6220 ROOSEVELT

REVIEW OF EDG & ADJUSTMENTS

COMMENTS FROM EDG REPORT 7/10/24

NE 63RD ST FRONTAGE

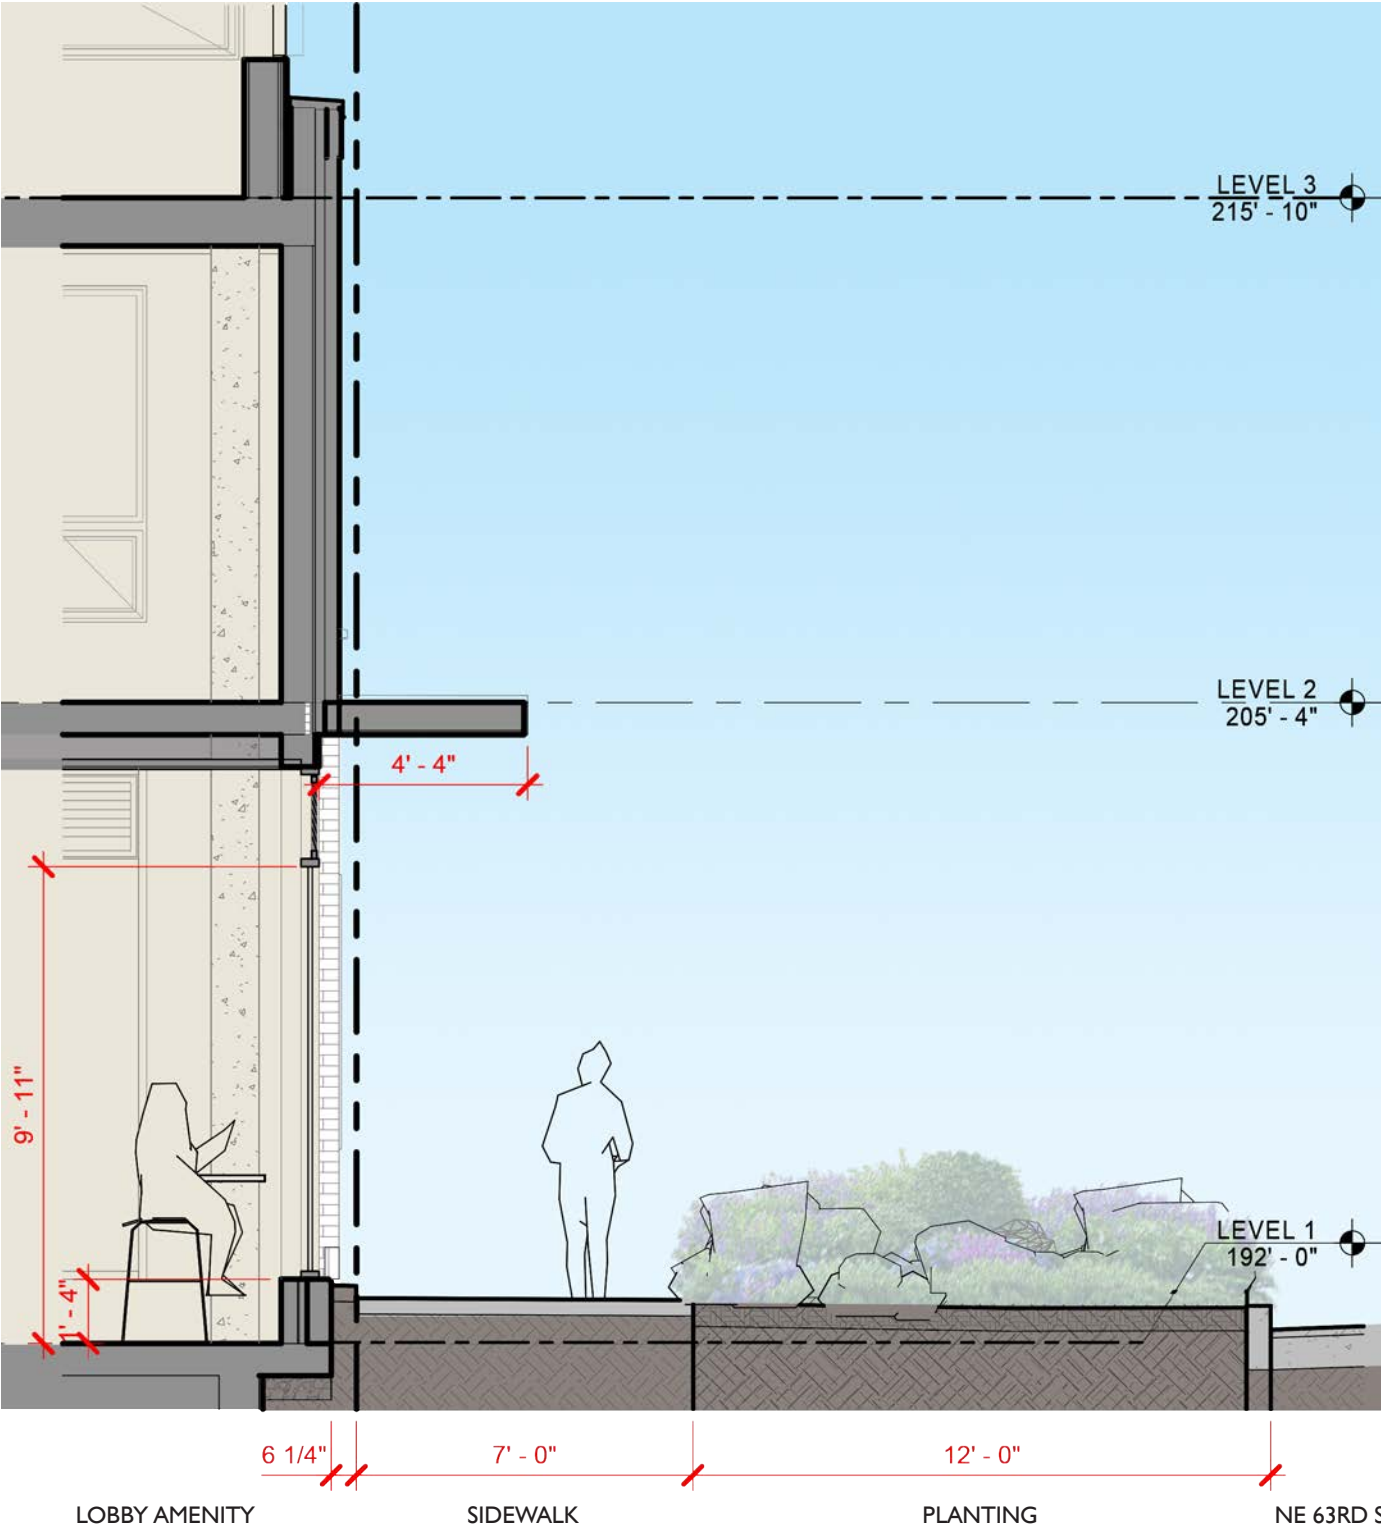
EDG Report Comment 2d:

The board wanted to ensure the necessary utility frontages are nicely incorporated into the street facades.
(See pages 8-11 for more information)

PL4.C.3: Adding a secondary entrance at the northeast end of the site provides a convenient entry for residents arriving from the Roosevelt Light Rail Station or arriving from the grocery just two blocks away.

CS2.III.iii.g / DC2.B.2: The wall mounted trellis and landscaping seamlessly incorporate the necessary utility frontage into the 63rd Street facade.

DC1.B.1 / DC1.C.4: Although the alley will remain unimproved after much negotiation with SPU, waste pick up will occur just inside the alley, removing the waste room roll up door from the street facing facade and allowing for a more pedestrian friendly streetscape.

SOUTHERN AMENITY ENTRY

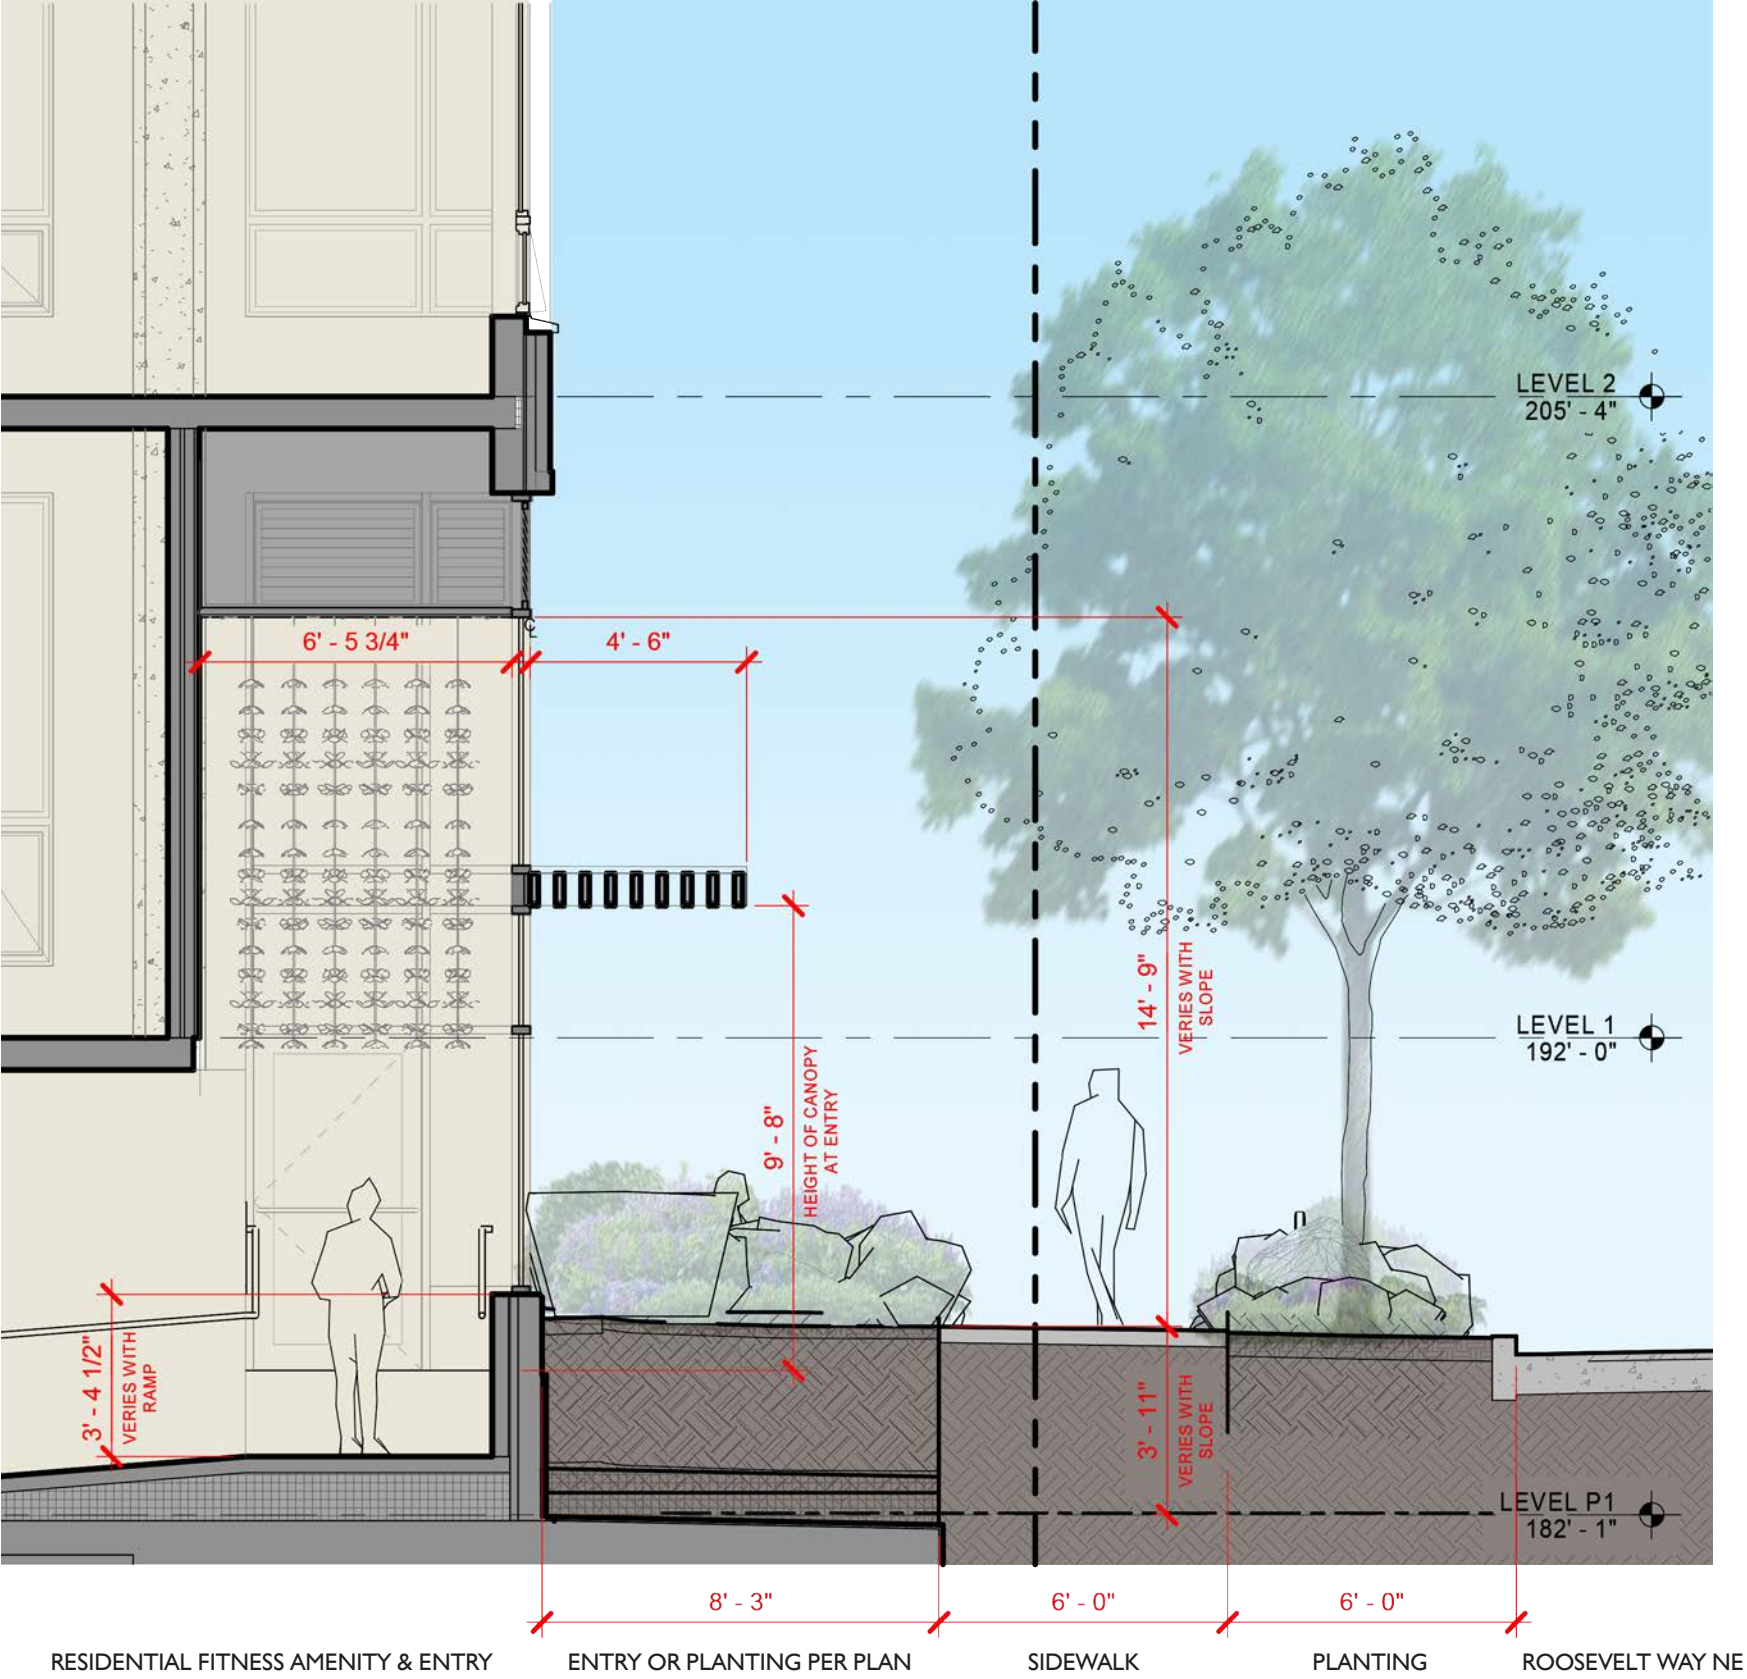
EDG Report Comment 2b:

The board wanted to ensure the building animates and engages Roosevelt and 63rd.

PL2.C: A large canopy provides weather protection at the amenity entry. Its unique slatted end over the planting allows for rain watering landscaping while keeping the pedestrian and seating area dry.

PL4.I / PL4.B: Cycling is likely to be a common and preferred method of transportation considering the nearby Light Rail, bicycle lanes, and parks. Providing a convenient, dedicated bicycle entry will be a lively and active part of the building program.

PL2.I.iii: Adjacent to this building's fitness and bicycle amenity spaces, the streetscape design includes amenities to aid in exercise.

ALLEYWAY

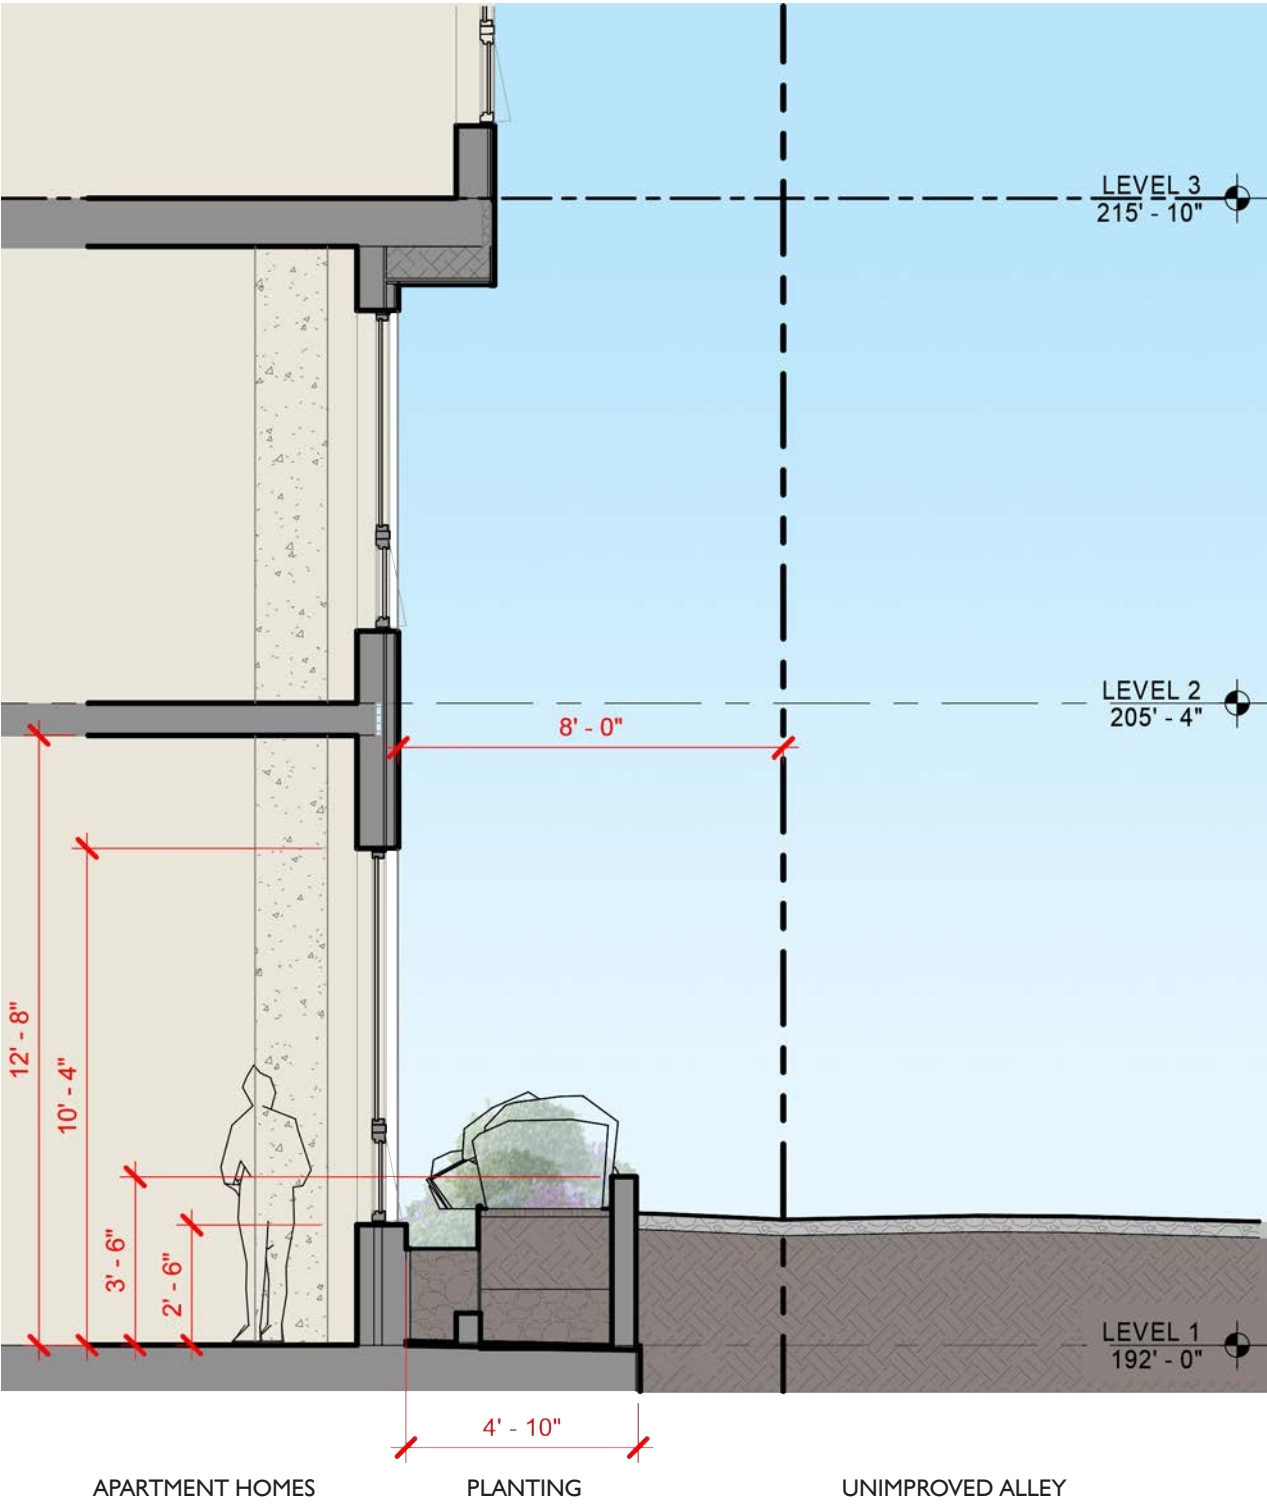
EDG Report Comment 3:

The board asked that the design evolution create an appropriate response to the alley that takes into account safety and promotes connectivity.

DC2.D.2: The addition of bands of wood-look facade adds rhythm, detail, and visual interest to the facade near grade.

PL2.B.1: Residential apartment homes, buffered with landscaping, provide excellent opportunity for visual surveillance of the alleyway.
